LANDMARKS BOARD STAFF REPORT

CASE: Certificate of Appropriateness

DESIGNATION: Commercial Street Historic District

LOCATION: 219 East Commercial Street

SOUTH - 2ND FLOOR
SCALE: 1" = 1'-0"

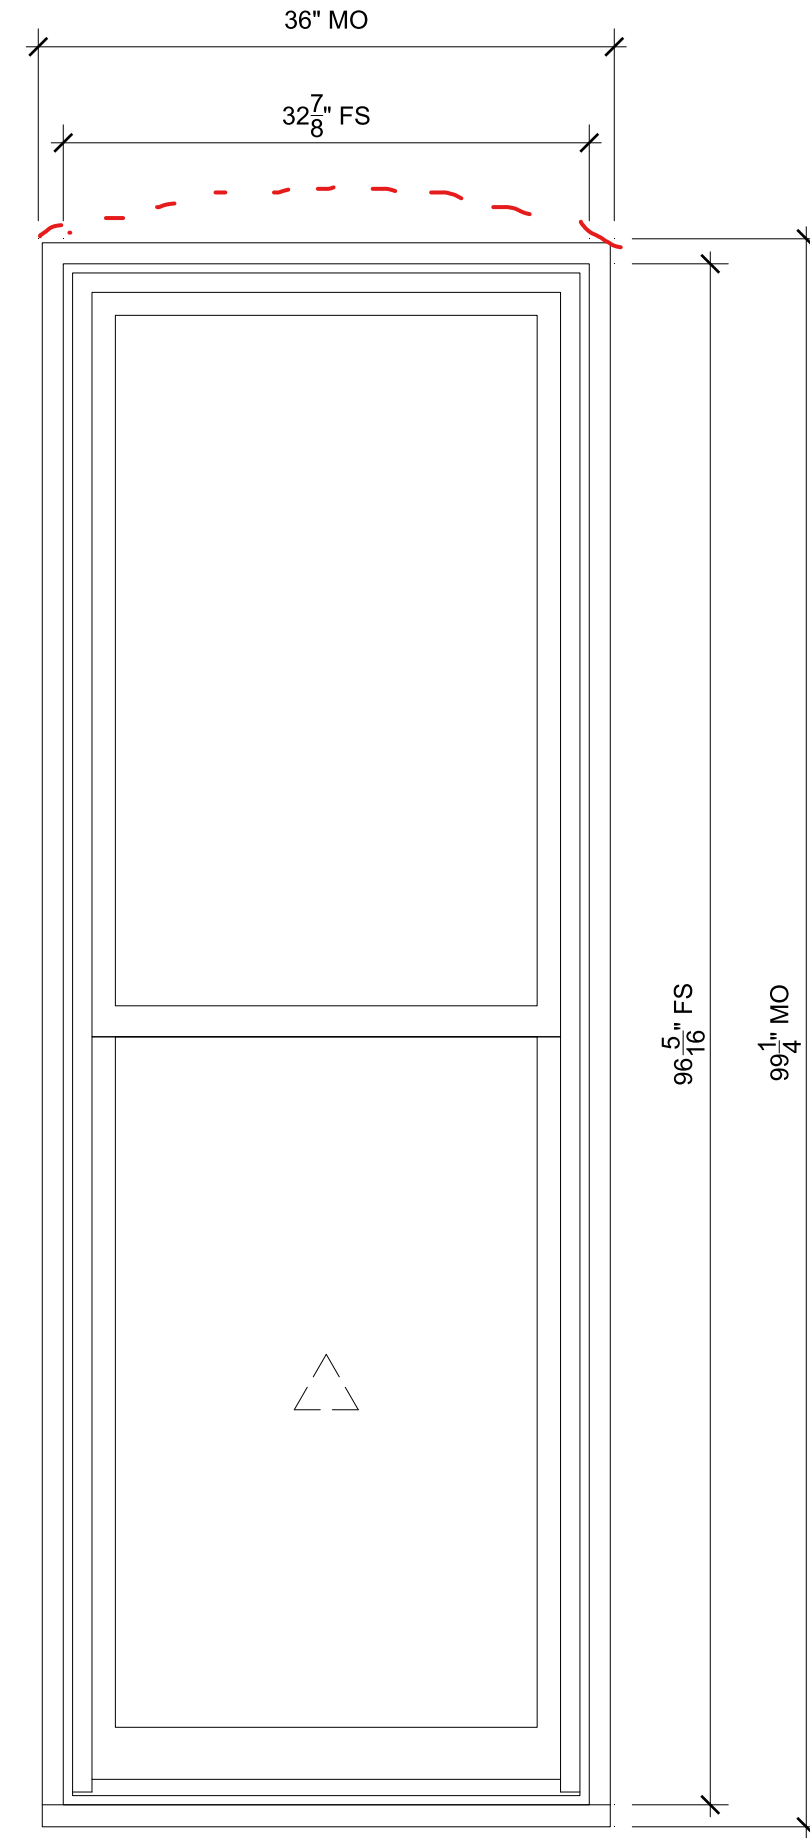
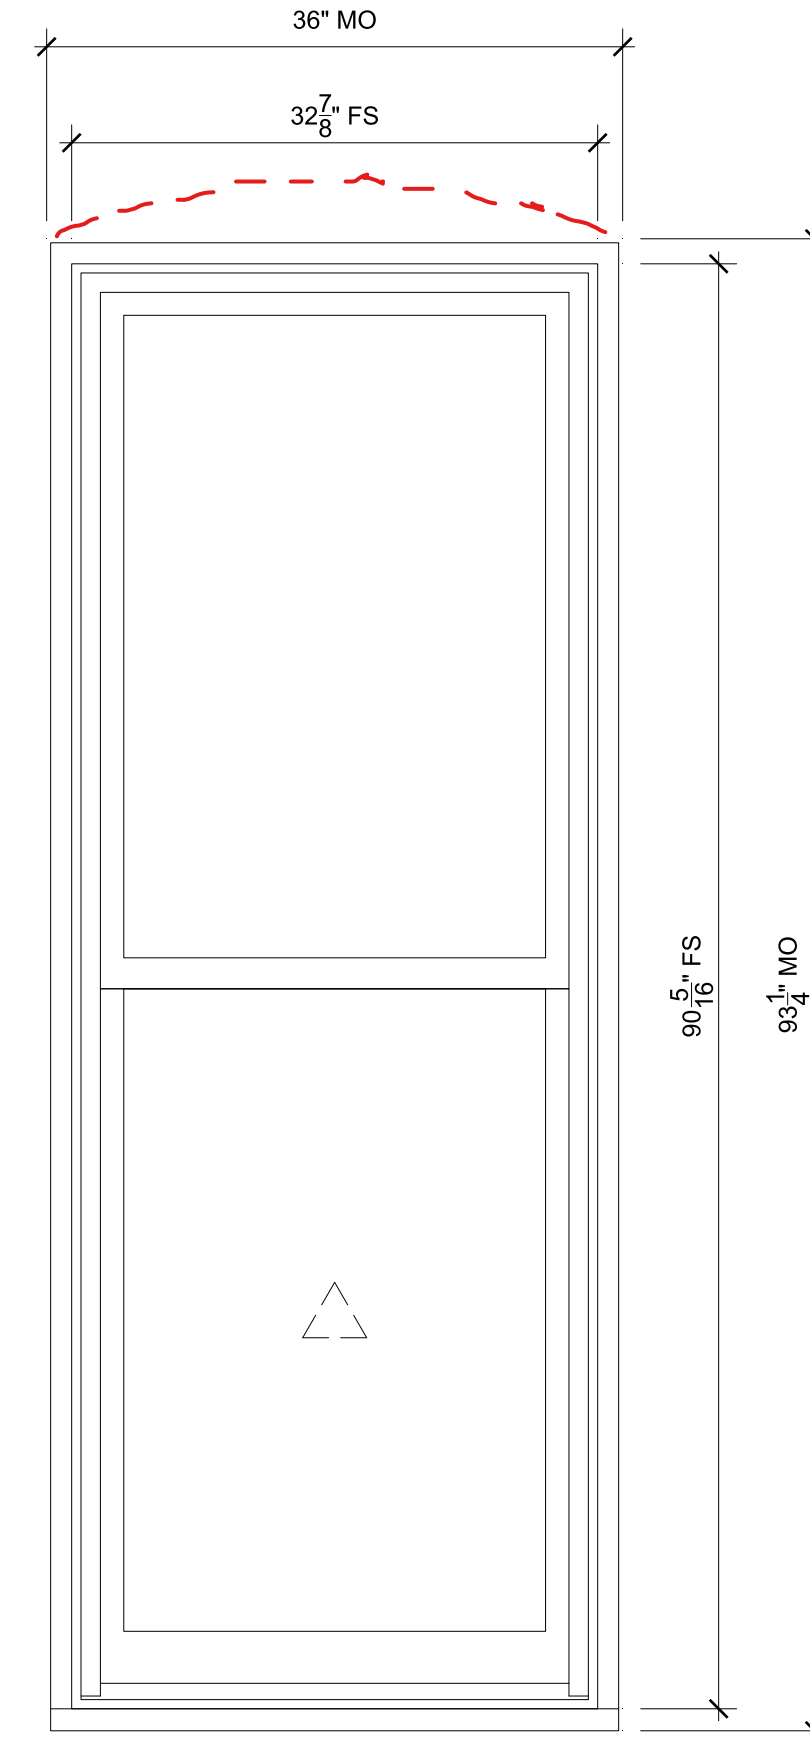
4. The windows to be replaced have an arched-head in the arched opening. The Design Guidelines recommend maintaining this configuration. The applicant is requesting to install windows that have a square-head upper sash with a filler panel in the arched openings. The use of a filler panel in the arched openings is not consistent with the Design Guidelines.

5. The *Secretary of the Interior's Standards* state, "Deteriorated historic features will be repaired rather than replaced. Where the severity of deterioration requires replacement of a distinctive feature, the new feature will match the old in design, color, texture and, where possible, materials." The existing windows are in a deteriorated state. Changing the style of window from an arched-head upper sash to a square-head upper sash with a filler panel does not match the existing feature.

Where repair is not feasible, replace existing windows with new wood windows that match the existing profiles, dimensions, muntin configuration, and sash heights. Install windows with brick mould that matches the original brick mould. Furthermore:

FILLER PANEL SITES ON COMMERCIAL STREET

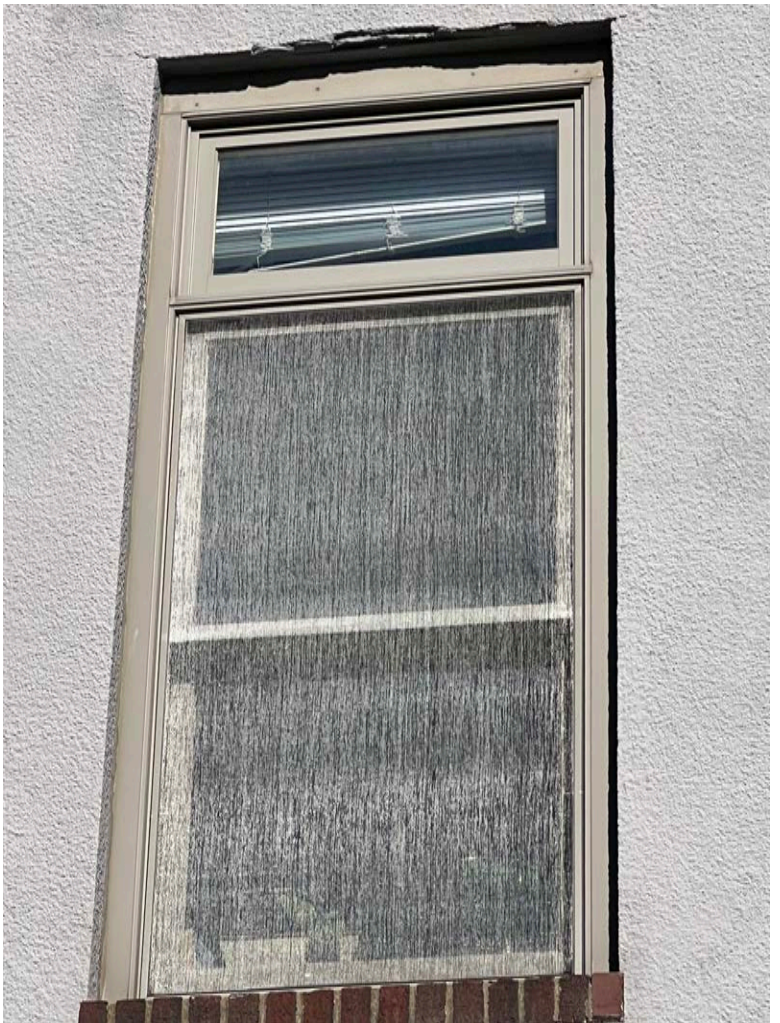
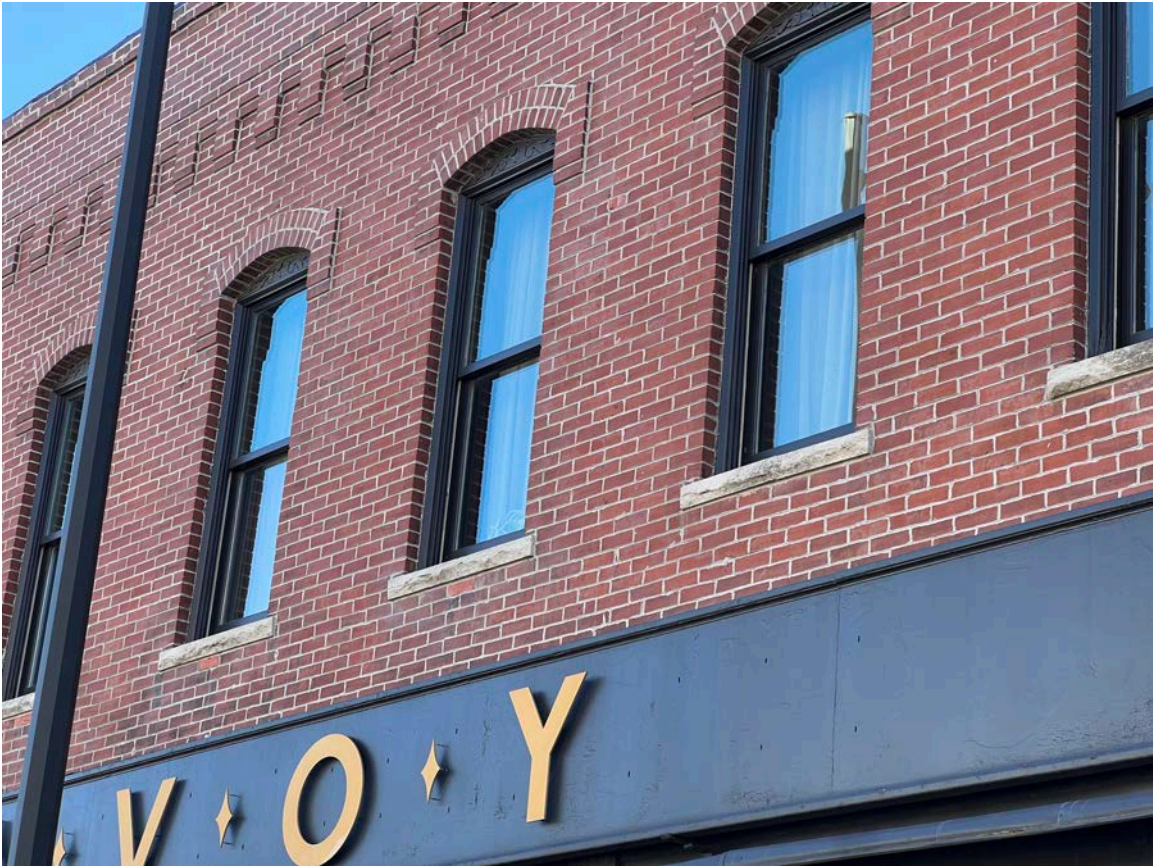
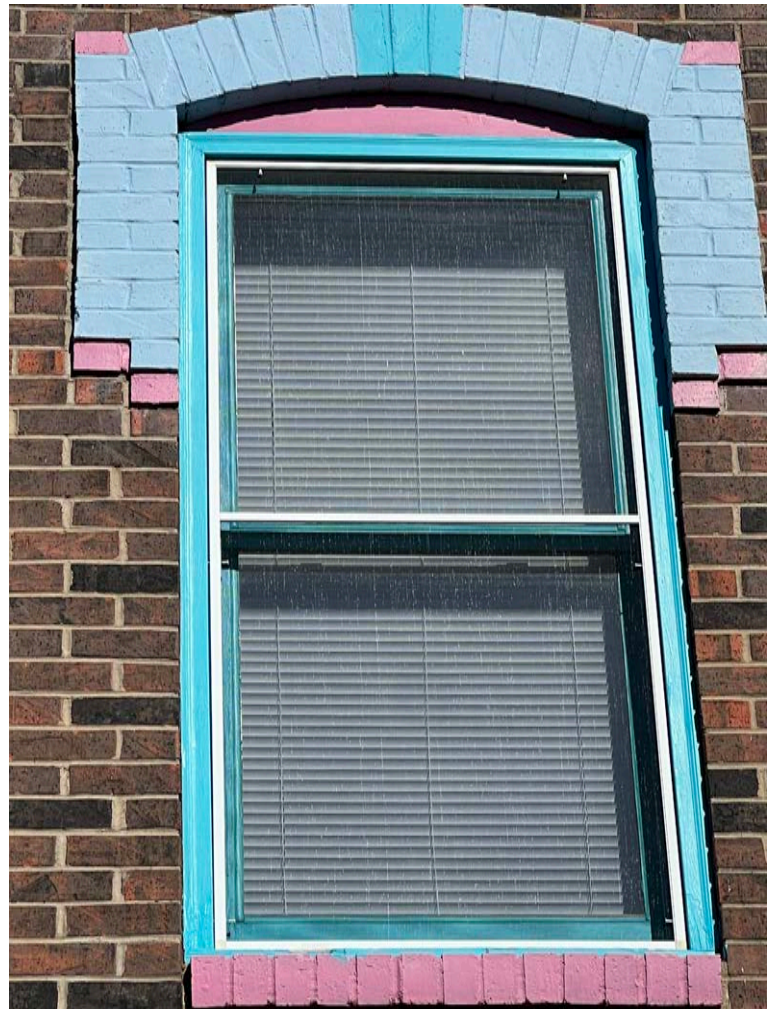
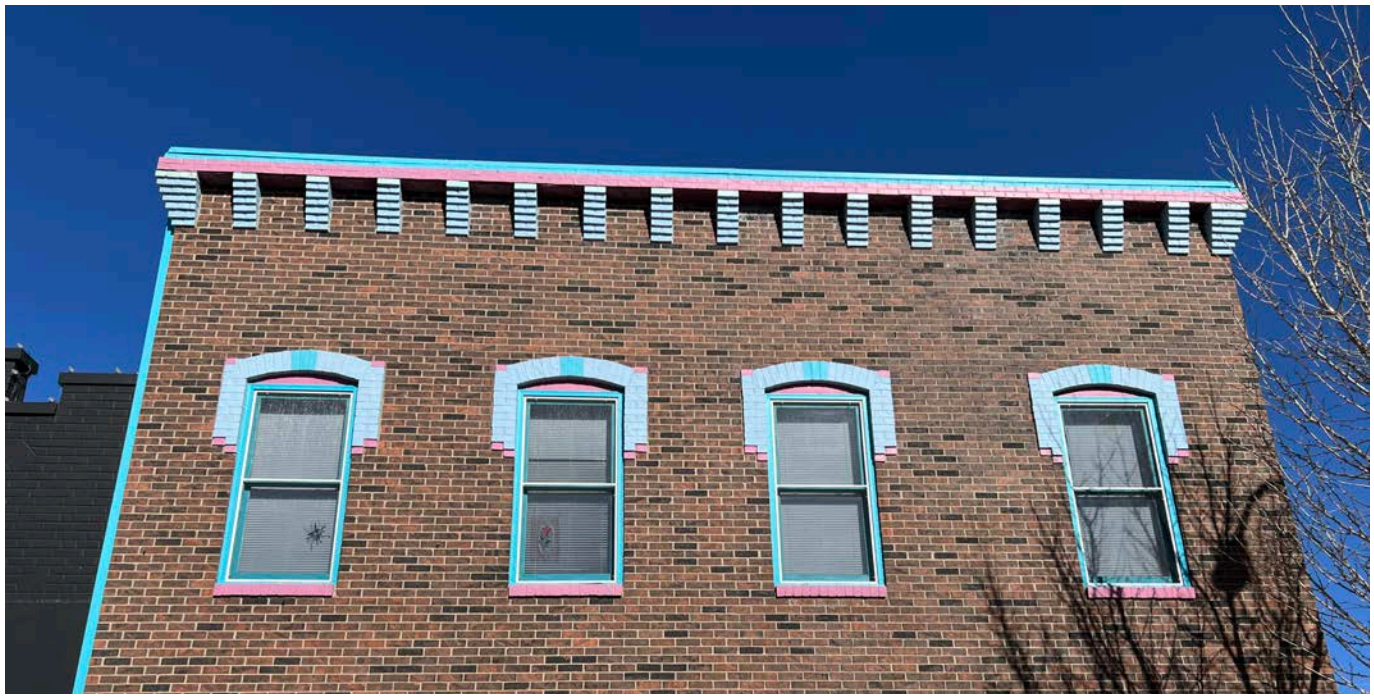
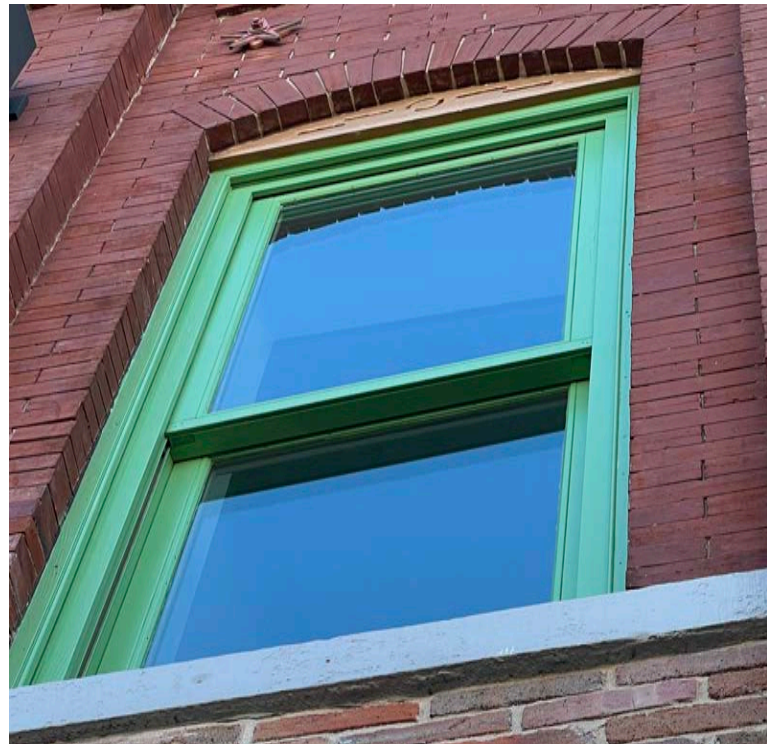
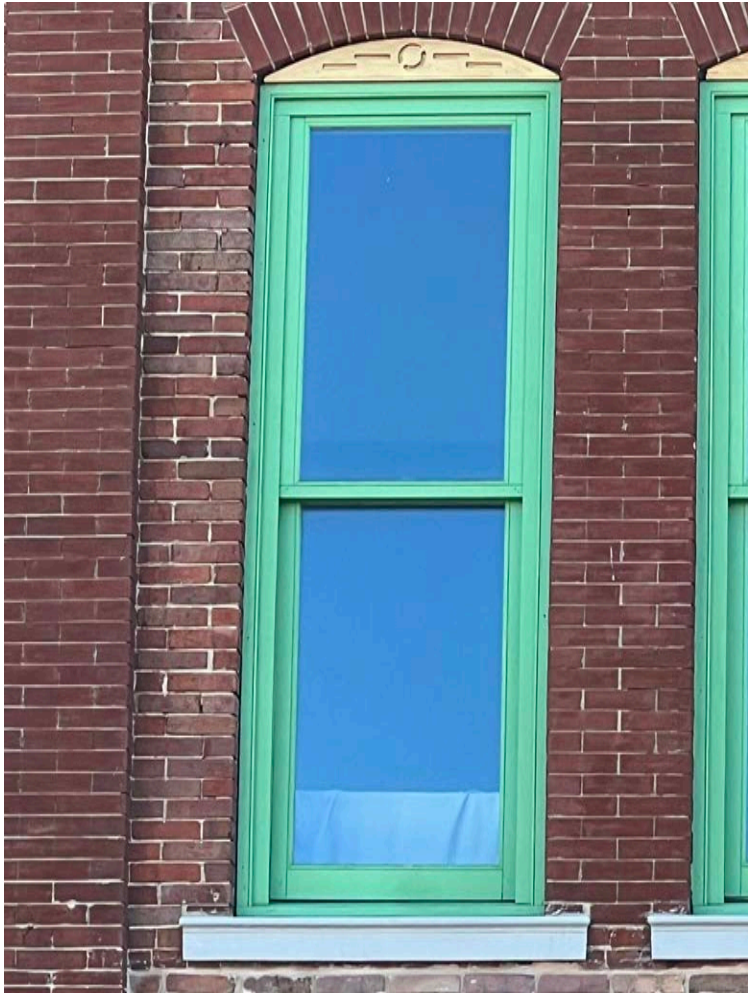
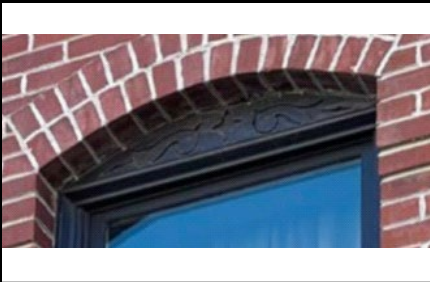
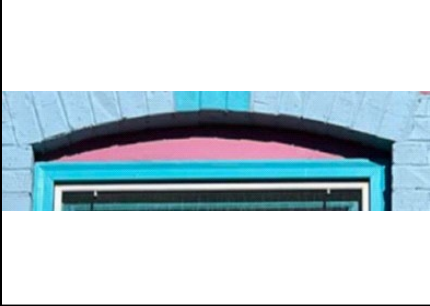
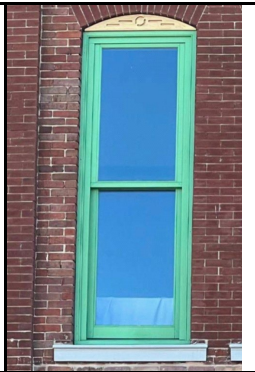
Address	Photo	Alternate Photo	Applicant Comments	Staff Response
<p>101 E Commercial St</p>			<ul style="list-style-type: none"> - Marvin windows - Composite infill material - This is a commercial window in a commercial application 	<p>Unknown time of window replacement; Historic photos (1917) show filler panels above windows on front façade</p>
<p>211 E Commercial St</p>			<ul style="list-style-type: none"> - Vinyl windows - Due to restrictions of a residential window maximum height, they had to use a maximum 80 inch hung window with a 16 inch transom window and a wood filled arch. - This is a residential window in a commercial application 	<p>Vinyl windows installed without a CoA between 2016 & 2017; Filler panels existed on front elevation at time of designation and prior to replacement</p>
<p>223 E Commercial St</p>			<ul style="list-style-type: none"> - Vinyl windows - Due to restrictions of a residential window maximum height, they had to use a maximum 80 inch hung window with a 16 inch transom window with a coil stock infill in the top. - This is a residential window in a commercial application 	<p>Windows on front elevation do not have arched-head upper sash; Front façade believed to have been significantly modified prior to designation in 1978</p>

<p>224 E Commercial St</p>			<ul style="list-style-type: none"> - Aluminum clad windows - Decorative wood infill arch - This appears to be a Pella window, roll formed aluminum exterior. This series of Pella windows is rated residential. 	<p>CoA issued in May 2011 for window replacement; Filler panels existed on front elevation prior to replacement</p>
<p>302 E Commercial St</p>			<ul style="list-style-type: none"> - Wood exterior replacement windows - Wood infilled arch - Window rating unknown 	<p>CoA issued in Dec 2003 for window replacement; Filler panels existed on front elevation at time of designation and prior to replacement</p>
<p>305 E Commercial St</p>			<ul style="list-style-type: none"> - Wood exterior replacement windows - Wood infilled arch - Window rating unknown 	<p>CoA issued in Sep 2009 for window replacement; Filler panels existed on front elevation prior to replacement</p>

<p>306 E Commercial St</p>			<ul style="list-style-type: none"> - Wood exterior replacement windows - Wood infilled arch - Window rating unknown 	<p>CoA issued in Nov 2006 for window replacement; Unable to locate detailed documentation of windows at time of replacement or designation; CoA states that the windows were replaced with "wood windows without a grill as to keep the same look...[as] the original windows"</p>

<p>1724 N Robberson Ave</p>			<ul style="list-style-type: none"> - Wood exterior replacement windows - Wood infilled arch - Window rating unknown 	<p>CoA issued in Mar 2015 for window replacement; Filler panels existed on street-facing elevations at time of designation and prior to replacement</p>
--	---	--	--	---
